DATE: August 18, 2011
TO: All Prospective Bidders

ADDENDUM NUMBER 2

CONTRACT NO. 60-11

**PRIMARY SEDIMENTATION AND
SLUDGE DIGESTION FACILITIES
AND
NEW LABORATORY, OPERATIONS BUILDING
AND ADMINISTRATION BUILDING RENOVATION**

C118
 SHEET
 47
 OF
 230

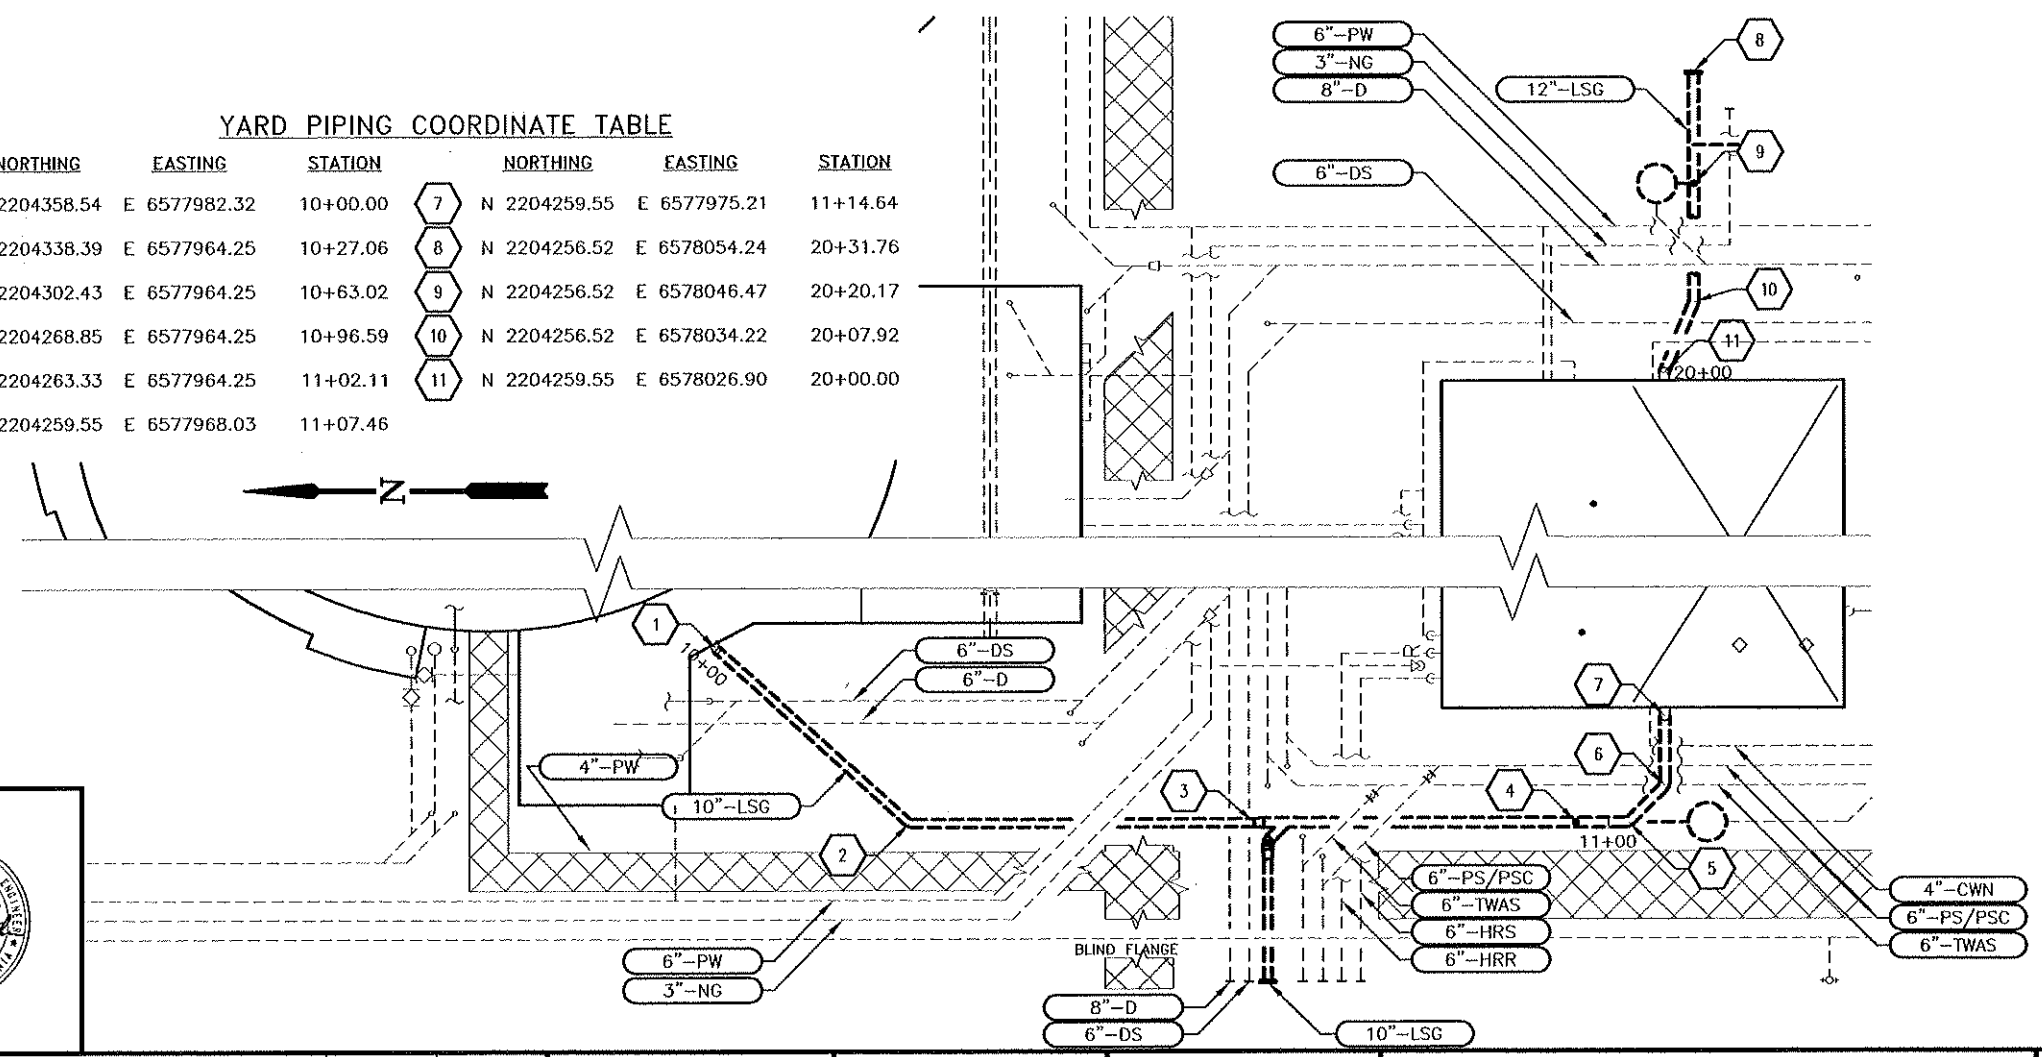
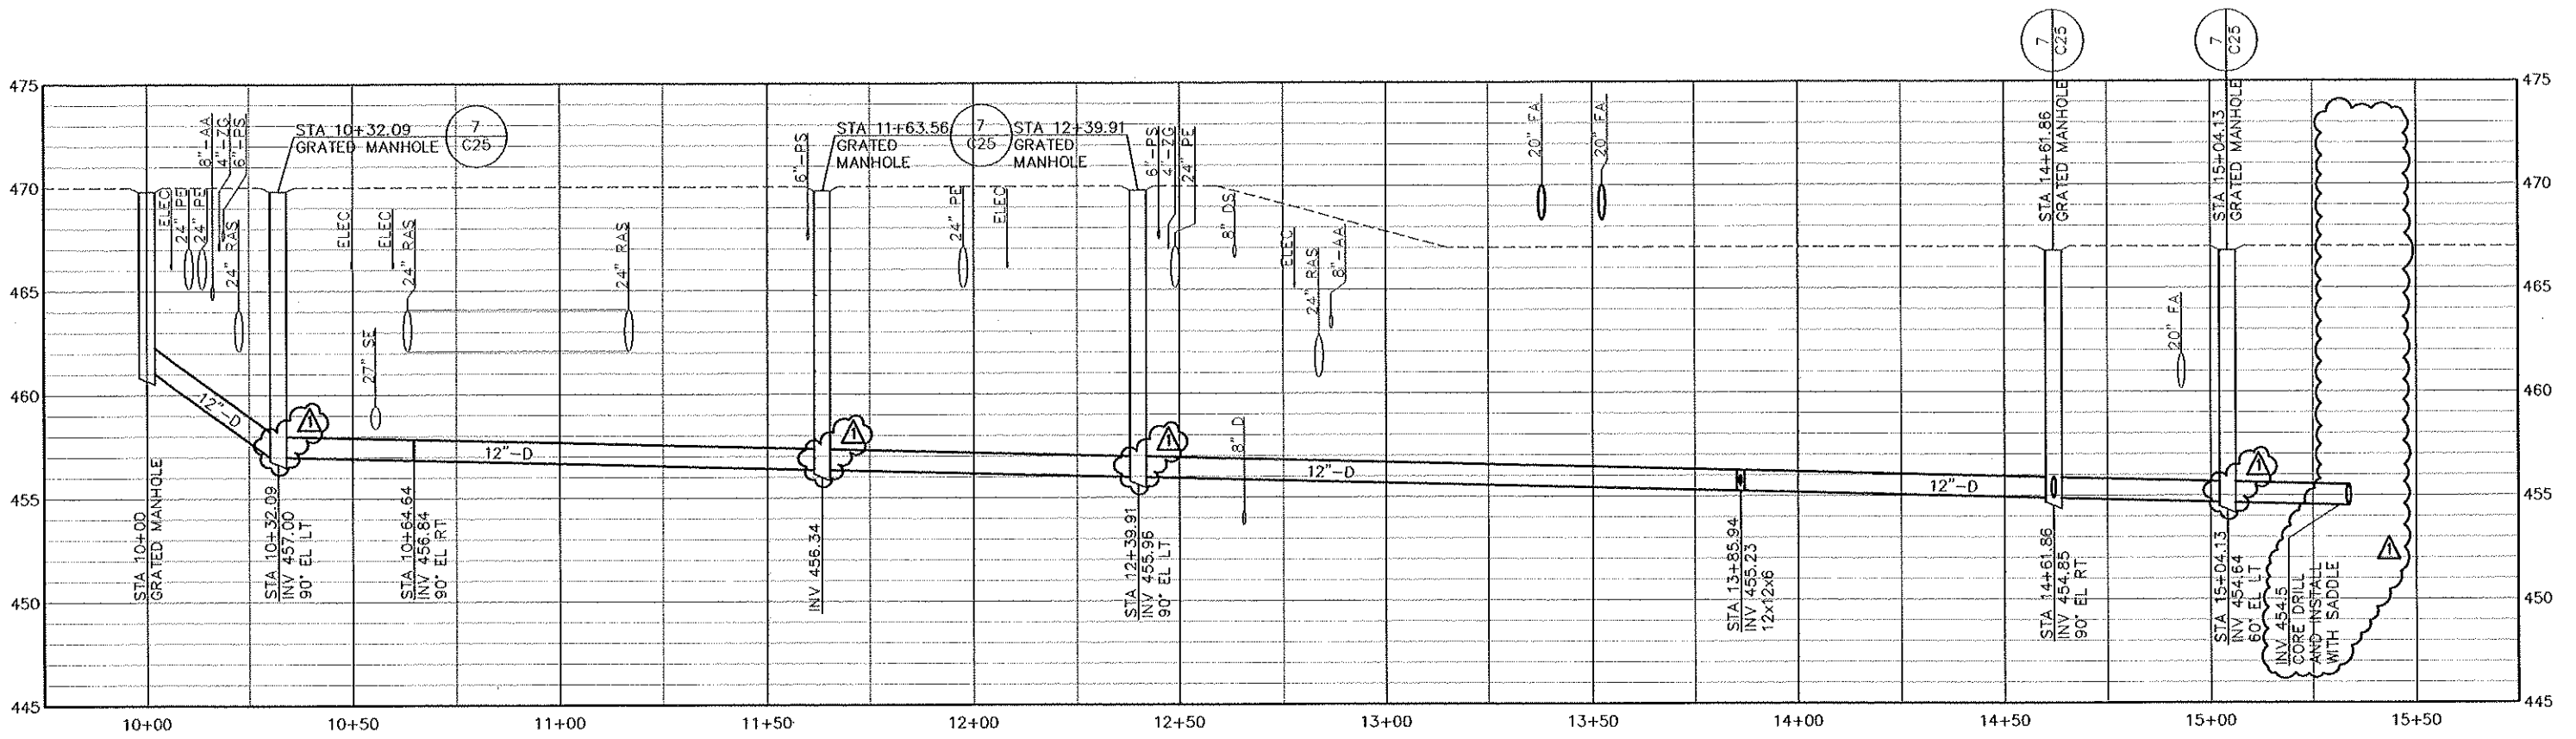
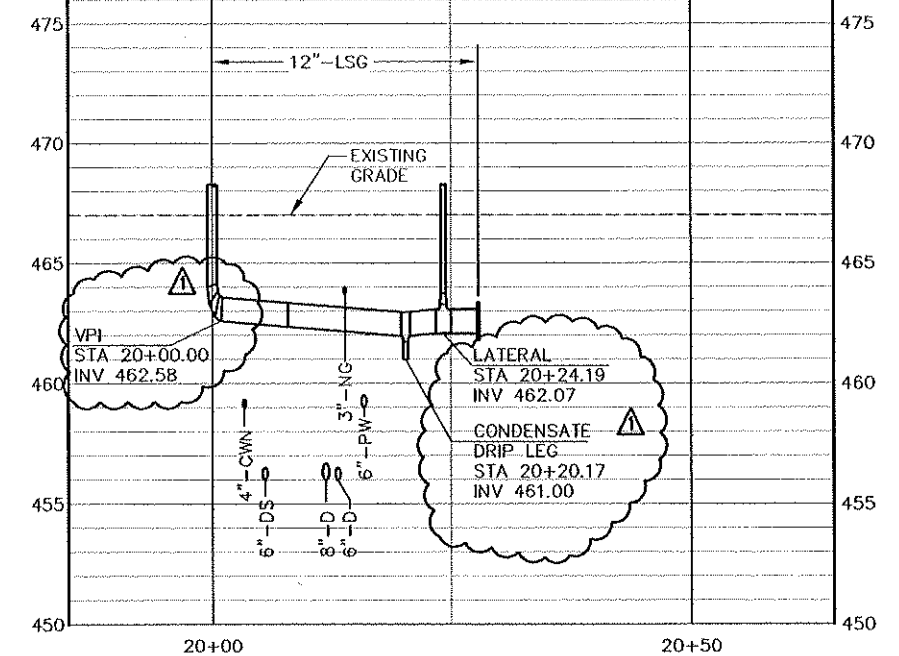
Drawing C118 indicates IE=461.19 at STA 20+00 but drawing M781, section C indicates IE=463.1 at the same location. Please specify the correct invert elevation.

Drawing C118 indicates IE=463.54 at STA 11+14.64 but drawing M781, section C indicates IE=463.1 at the same location. Please specify the correct invert elevation.

Drawing C118 indicates IE=463.97 for the lateral at STA 10+65.35 but drawing C18, section A indicates IE=461.00 at the same location. Please specify the correct invert elevation.

Drawing C118 indicates IE=463.19 for the condensate drip leg at STA 10+96.59 but drawing C18, section B indicates IE=461. Please specify the correct invert elevation.

Drawing C118 indicates IE=455.98 for the condensate drip leg at STA 20+20.17 that locates it below the 6" D invert of 458.35 at the manhole shown on C114 for Drain 8. Please specify the correct elevation.

Drawing C118 LSG profile invert elevations do not match vertical reference elevations on grid. Please clarify.

Drawing C118 is correct.

The invert elevation of 460.78 as shown on Drawing C118 is at Station 10+65.85 and the lateral shown on Section A Drawing C18 is sloped up to elevation 461.0.

The invert elevation at Station 10+85 on Drawings C118 is approximately 460.35 and invert elevation on Drawing C18 should read 460.35.

Drawing C118 will be reissued with updated invert elevations.

C121
 SHEET
 50
 OF
 230

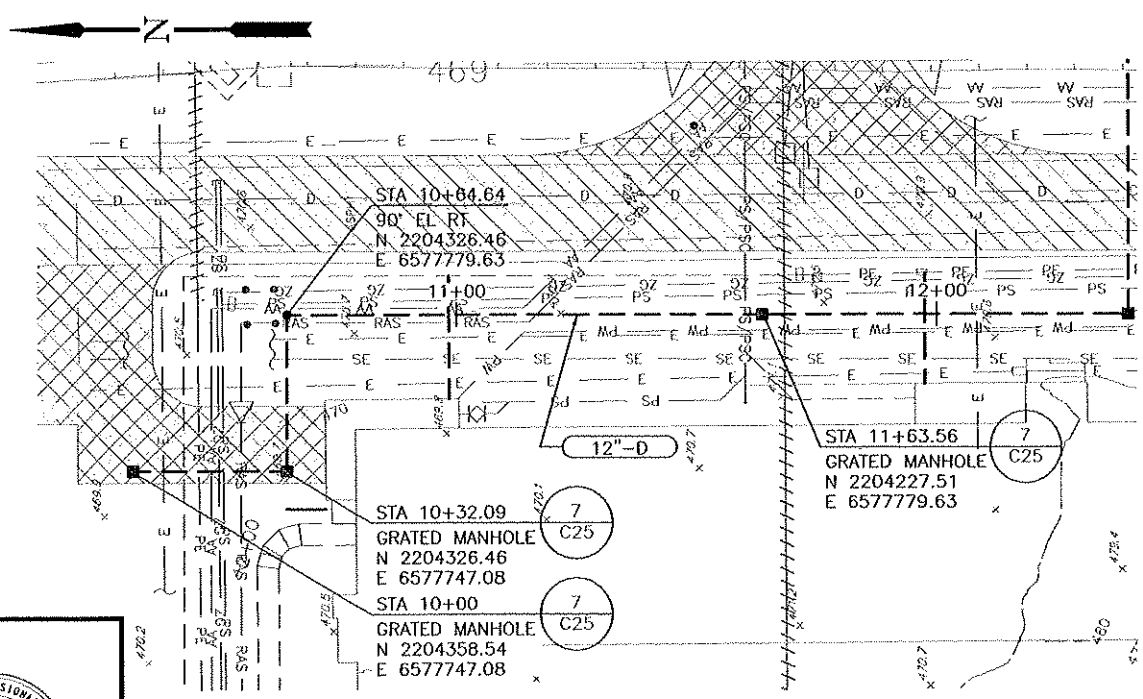
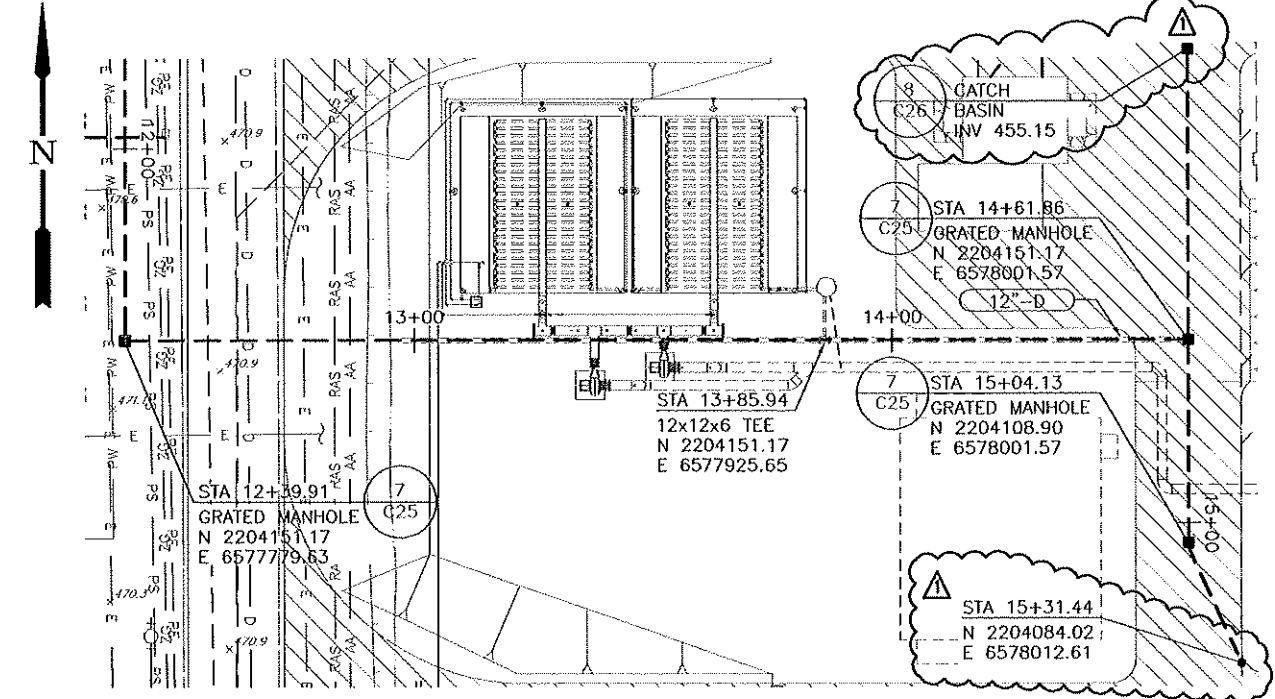
Drawing C121, plan view shows a D running north from the manhole at STA 14+61.86 but does not provide a profile or termination detail for this run. Please provide details of the D running north from STA 14+61.86.

Drawing C121 will be reissued showing continuation of drain to the north.
